Notice of Allowability

09/928,402

FREIDHOF ET AL.

1st OA

Fig. 6

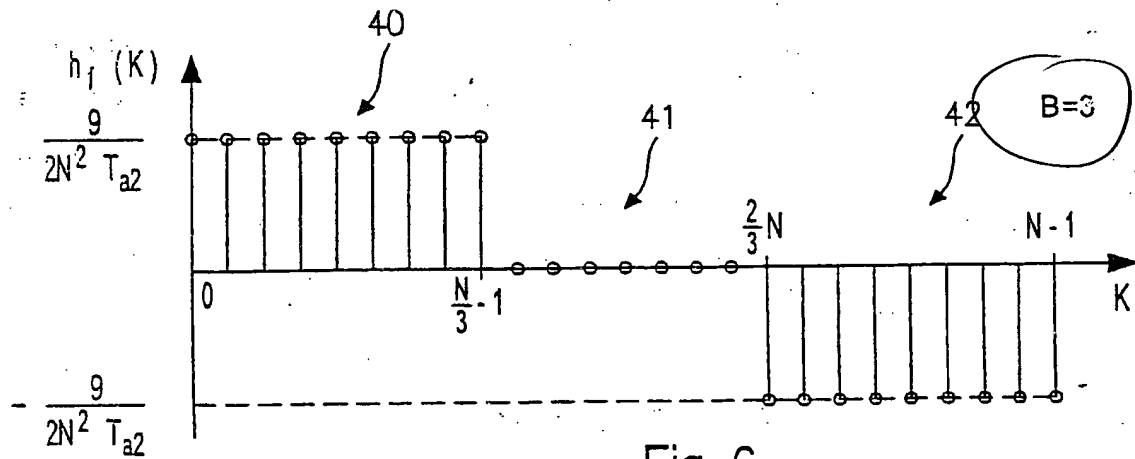
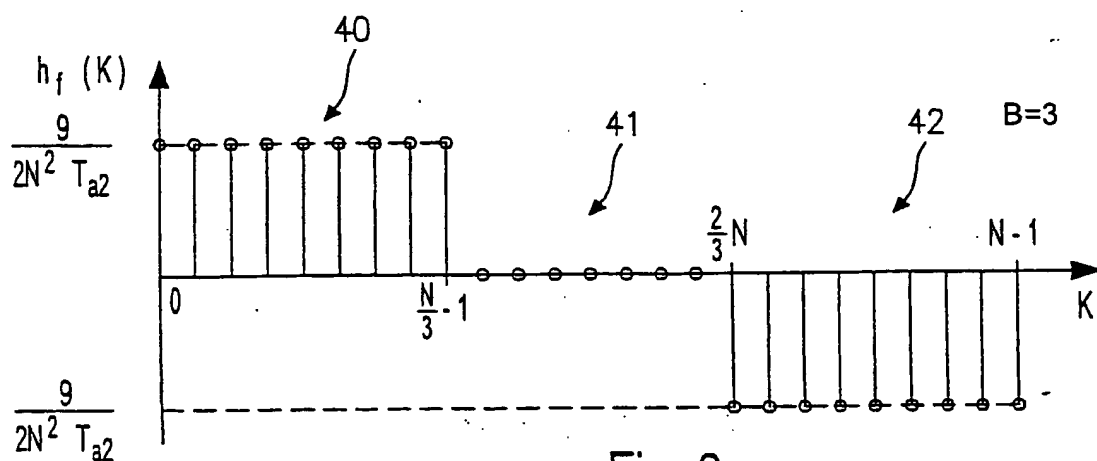
The drawings are objected to under 37 CFR 1.83(a). The drawings must show every feature of the invention specified in the claims. Therefore, the features of claims 1, 2, 8, 9, 10, 11 and 12 for a general value of B and for $B=3n$ must be shown or the feature(s) canceled from the claim(s). No new matter should be entered.

To Figs. 6 and 7, the reference label "B=3" was added, and to Figs. 9 and 10, the reference label "B=6" was added.
